Access Compliance Report

Public Rights-of-Way

(Curb Ramps)

Intersection ID: 12521	Main Street: BELVEDERE_AV	Cross Street: CHATHAM_AV	Location: SE
ADA ID: 1F838206E55B	Ramp Type: Perp	Initial Pass/Fail: Fail	Overall Compliance: No
Severity Score: 21.25			
Codes/Mitigation Info/Possible Solution		Field Measurements/Component Compliance

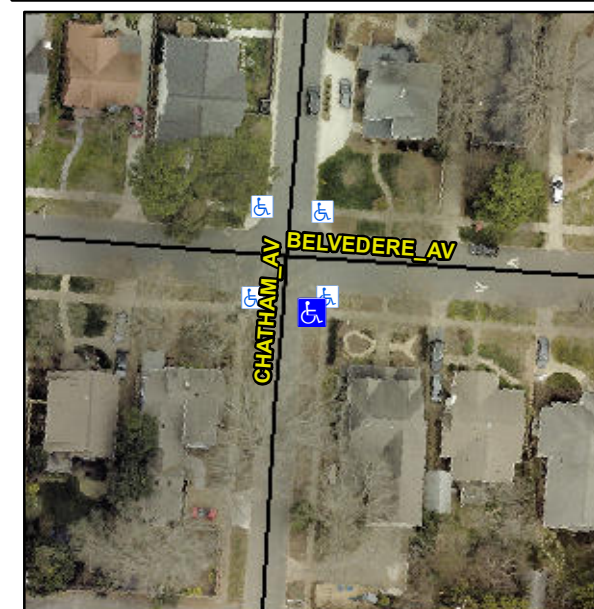
R304.5.1, R304.5.3

Compliance	Description	Data	Compliance	Description	Data
N/A	Ramp Length (in)	47.0	Yes	Ramp Slope (%)	8.1
No	Ramp Width (in)	42.0	No	Ramp XSlope (%)	5.2
N/A	Flare Type LT	N/A	N/A	Flare Type RT	N/A
N/A	Flare Slope LT (%)	N/A	N/A	Flare Slope RT (%)	N/A
N/A	Flare Traversable LT?	N/A	N/A	Flare Traversable RT?	N/A
N/A	Landing Length (in)	N/A	N/A	DWS Provided?	N/A
N/A	Landing Width (in)	N/A	N/A	DWS Contrast?	N/A
N/A	Landing Slope (%)	N/A	N/A	DWS Length (in)	N/A
N/A	Landing X Slope (%)	N/A	N/A	DWS Full Width?	N/A
N/A	Landing Curb? (Y/N)	N/A	N/A	DWS Offset (in)	N/A
N/A	Shared Landing?	N/A			
N/A	Gutter Ponding?	Yes	N/A	Gutter Slope (%)	N/A
N/A	Gutter Lip Ht (in)	N/A	N/A	Gutter X Slope (%)	N/A
N/A	Painted X Walk1?	No	N/A	Painted X Walk2?	N/A
	X Walk 1 Direction	To W		X Walk 2 Direction	N/A
N/A	X Walk 1 Width (in)	N/A	N/A	X Walk 2 Width (in)	N/A
	X Walk 1 Slope (%)	5.1		X Walk 2 Slope (%)	N/A
	X Walk 1 X Slope (%)	0.6		X Walk 2 X Slope (%)	N/A

N/A	Ramp inside XWalk1?	N/A	N/A	Ramp inside XWalk2?	N/A
	Road Slope (%)	N/A	N/A	Clear Space?	N/A
	Road X Slope (%)	N/A	N/A	Clear Space to XWalk (in)	N/A
N/A	Any Obstructions?	N/A	N/A	Storm Grate/Utility Hazard?	N/A
	Obstruction Type			Storm Grate/Utility Type	
		N/A			N/A
		Yes		Surface Condition? (G/P)	Good

Remove & Replace Entire Ramp.
